TECHNICAL SERVICE BULLETIN

C-GN-OT-0063

Subject: **Wiring Changes Required for Refrigerant Detection System with Zoning Integration Kit**

Figure 1

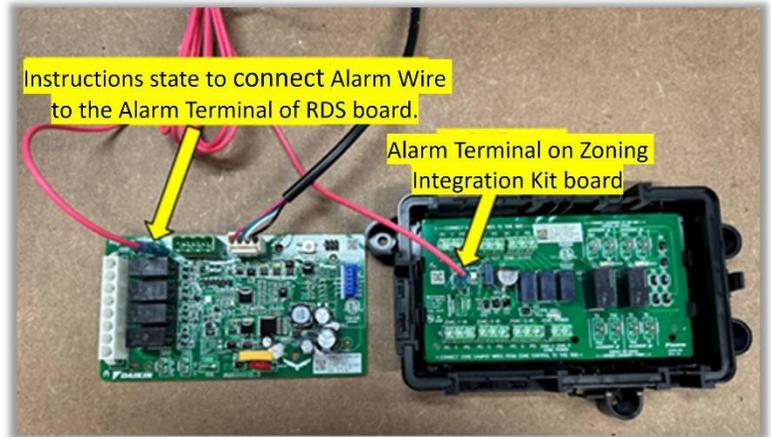
The instructions provided with the Zoning Integration Kit state to connect the “Alarm” terminal from the RDS board to the “Alarm” terminal of the Zoning Integration Kit board as shown in Figure 1. With this incorrect wiring, the “Alarm” terminal of the RDS board will energize anytime a “G” (Fan) signal is present from the thermostat. This will cause the Zoning Integration Kit board to open all dampers and turn off all accessories during normal HVAC operation.

Figure 2

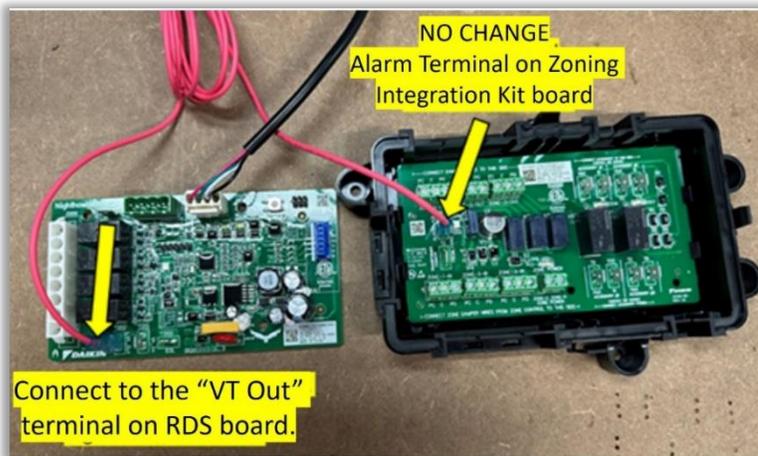
When installing the Zoning Integration Kit with the models in the table above, follow the steps below for correct wiring between the RDS board and the Zoning Integration Kit board, plus the addition of a necessary jumper wire on the RDS board.

1. Turn off all power going to the unit.
2. Remove control panel cover to access the control box.
3. Remove the wire from the “Alarm” terminal on the RDS board that comes from the “Alarm” terminal on the Zoning Integration Kit board.
4. Connect this wire on the “VT Out” terminal on the RDS board as shown in Figure 2.
